GLOVEBOX AREA RATTLE

TECHNICAL SERVICE BULLETIN

Reference Number(s): 76/08/99/NAS,Â Date of Issue:Â May 19, 1999

LAND ROVER: Discovery Series II

Fig. 1: Cable Tie Locations

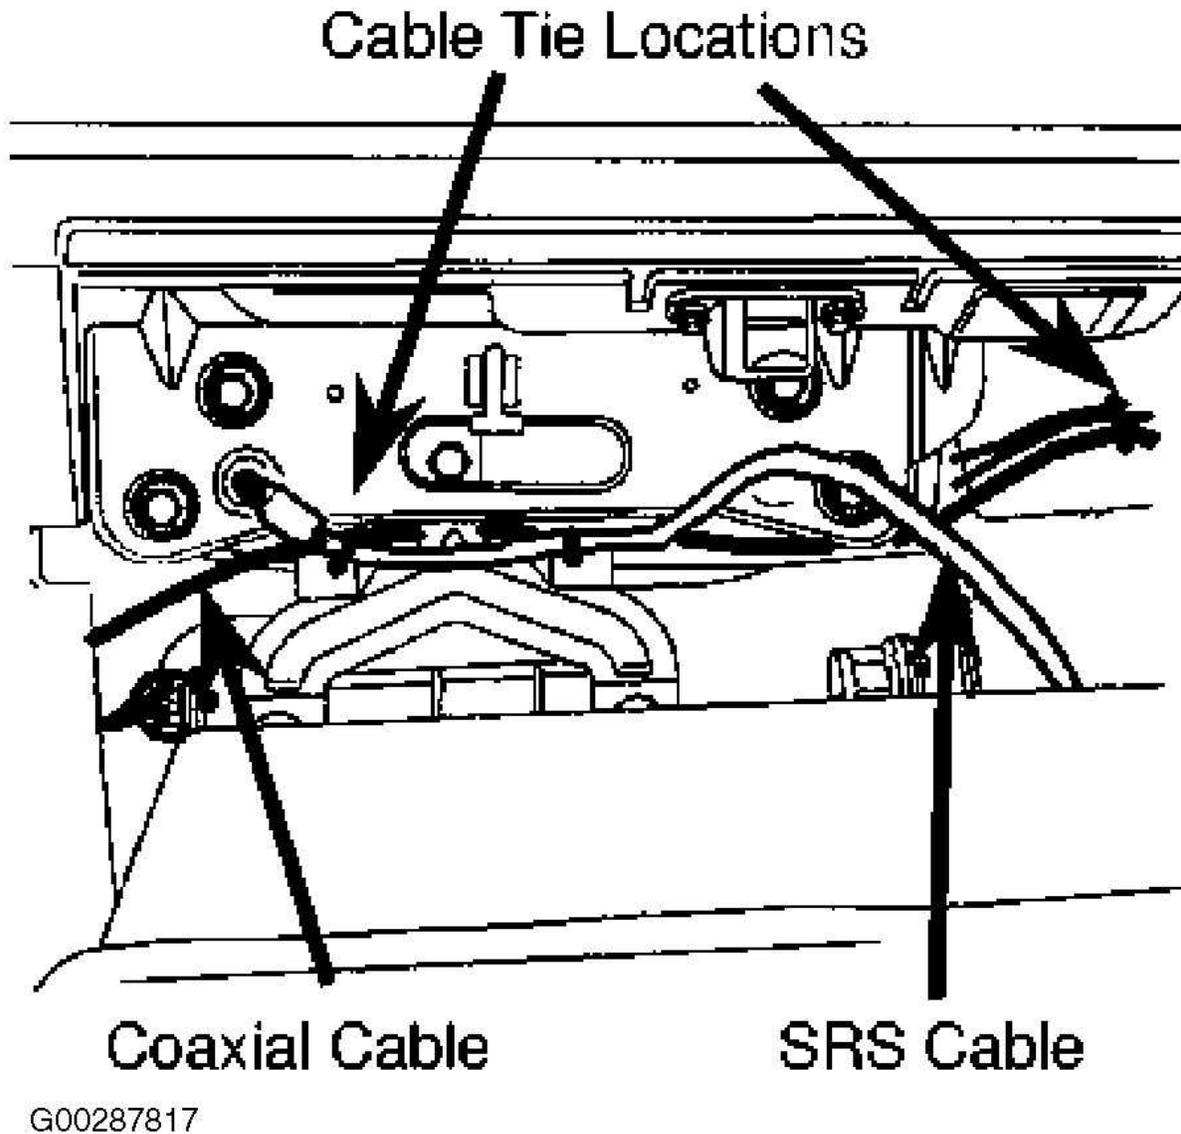
1. Lower the glove box.
2. Release side latches to drop the glovebox completely down for access behind the dash panel.
3. Inspect to determine that the coaxial cable is located behind the HVAC blower mounting bracket and

that it is secured with a cable tie on the left side.

4. If inspection reveals that routing and cable tie are not properly made, remove the two bolts securing the blower-mounting bracket.
5. Locate the cable behind the HVAC blower and install the mounting bracket.
6. Secure the SRS wire and coaxial cable to the blower mounting bracket on left side with a cable tie. See [Fig. 1](#).
7. If slack is apparent in cable cluster on right side, secure with a cable tie.
